Issue Date Sep 29 2020
 PCN Ref. No. CTOS-200349

Subject: PCN Notice for Thermal Printers

Product Name	Thermal Printer
Part Number	Please refer to the attached "PN list"
Description of Change	Photo sensor is going to be changed to another vendor's.
Reason for Change	The current photo sensor is going to be terminated EOL.
Schedule	Samples : Available upon formal request
	Implementation effective date : Starting October 1, 2020 and completed by March 2021.
Control of Change	Product revision is changed.
Detailed Description	Please refer to the attached "Comparison Table".
Impacts	Data sheet : Product revision is changed.
	Product spec : NO changes
	Product appearance : NO changes
	Product part number /Revision number : Product revision is changed.
	Price : NO changes
Attachment	
Request	<input checked="" type="checkbox"/> Please announce your customers of this change. For any questions or concerns, please contact us by Oct 30, 2020 <input type="checkbox"/>
Others

Margin of detection width

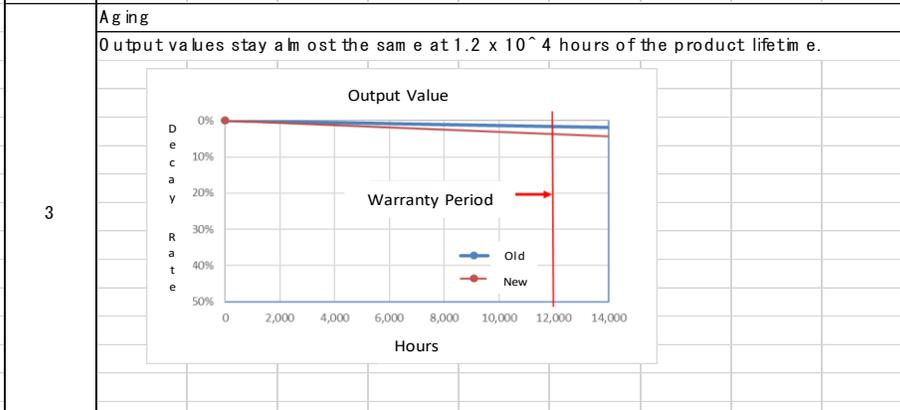
Margin has been increased to detect the actual width of the mark.

Condition : Power Supply 3.3V Mark width 5mm Mark reflection rate 7%

Detection response time at below 2V - 43.2ms → width 4.32mm

Detection response time at below 2V - 46.4ms → width 4.64mm
